Premium POS Industry

Old frame
New frame

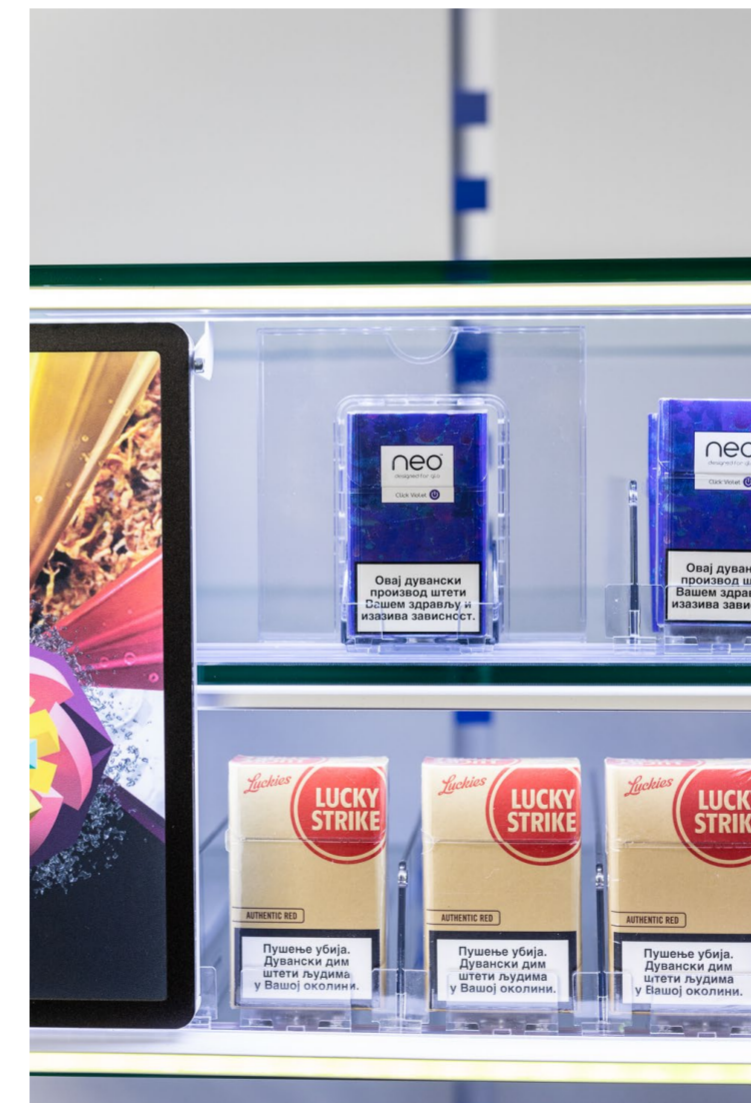
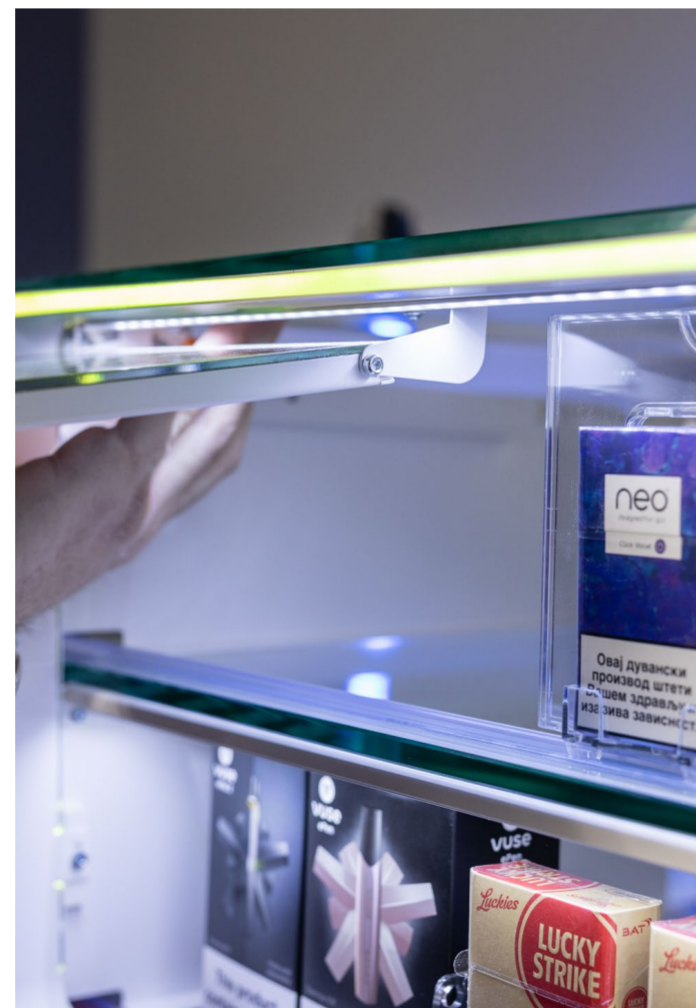
1. Stripes removed

02. "L Shape" removed
GLO/Vuse device products are
now easier to handle and
maximum available height
used.

03. As agreed
additional holes made for
better air flow and cooling

4. Edges curved as per request

05. LED lamps covered for safety

06. No visible black and red cables

7. Fixed flap and implemented with agreed gap.
Small flap one row can replace one big flap.

08. GLO tray + Commsmodule

09. Packaging size reduced by 70%

RGB LED Stripes

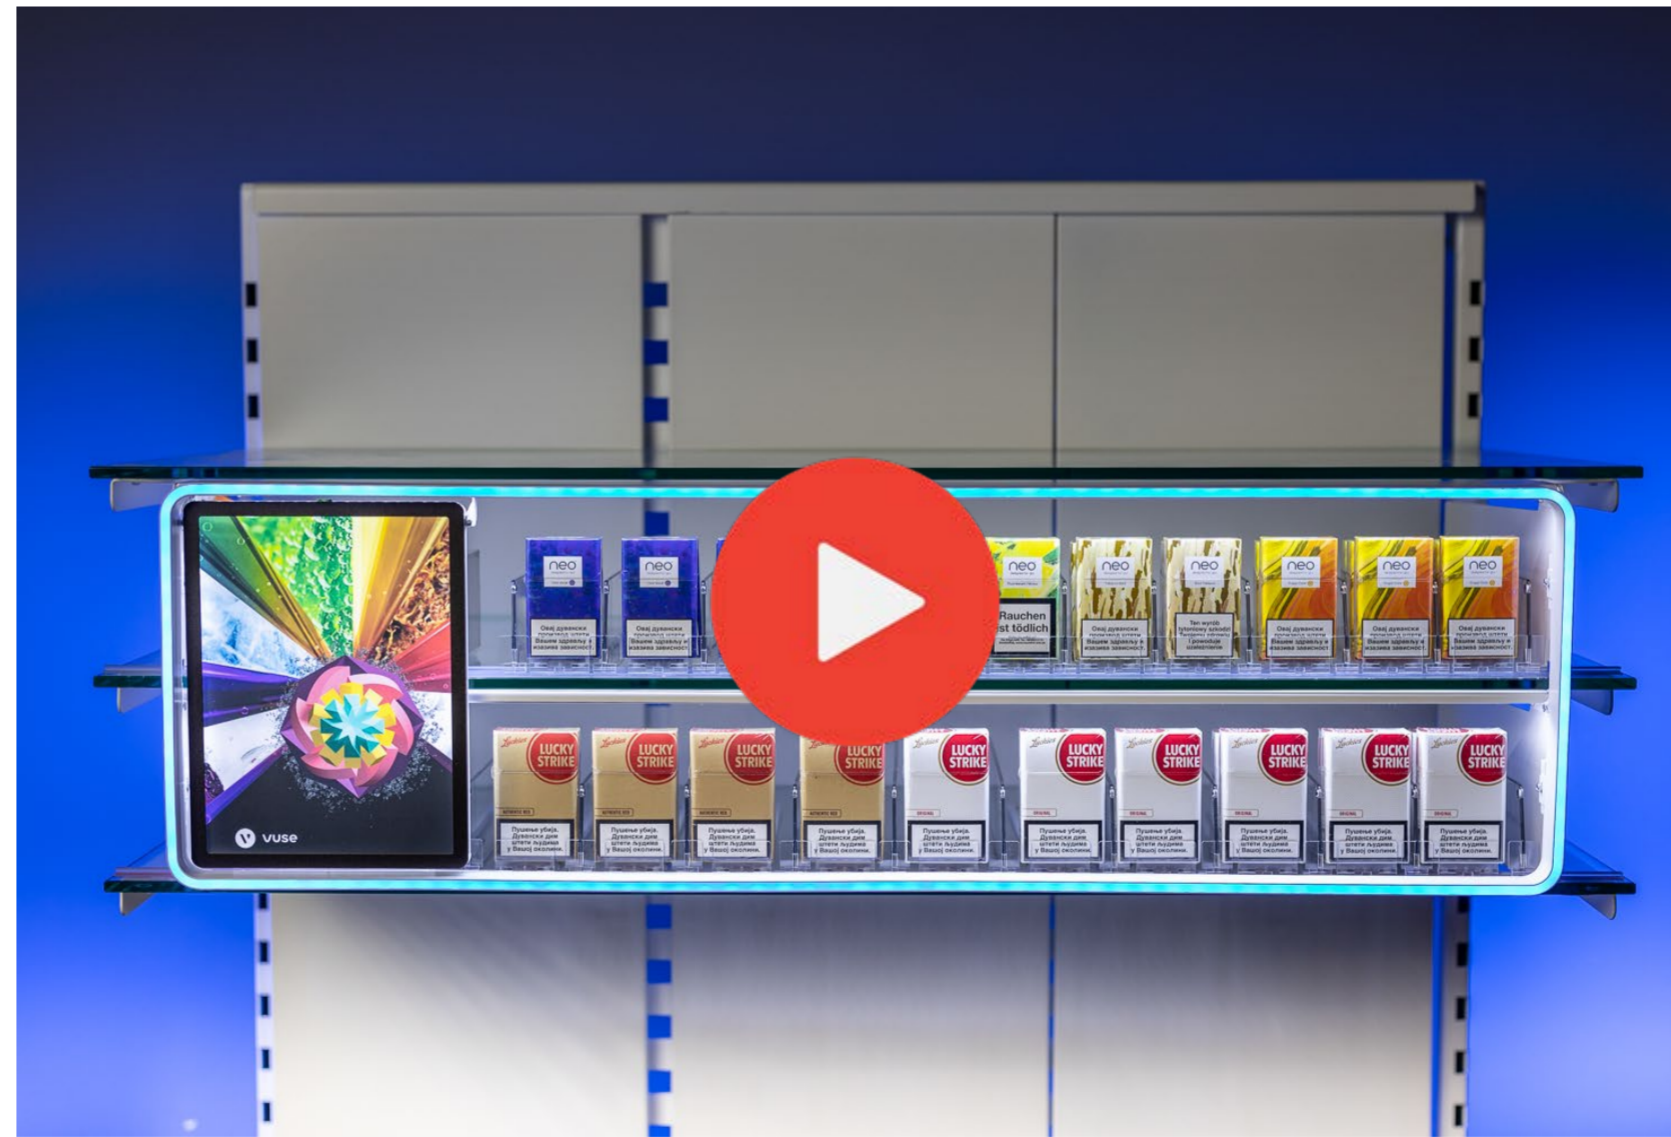
- 10 or more colors available (TBA)
- No dimmers and ON/OFF switch removed
- Remote controller removed
- As agreed, hidden button implemented (photo)
- As already communicated "code" for switching ON/OFF will be implemented in mass production. (Please see video bellow)
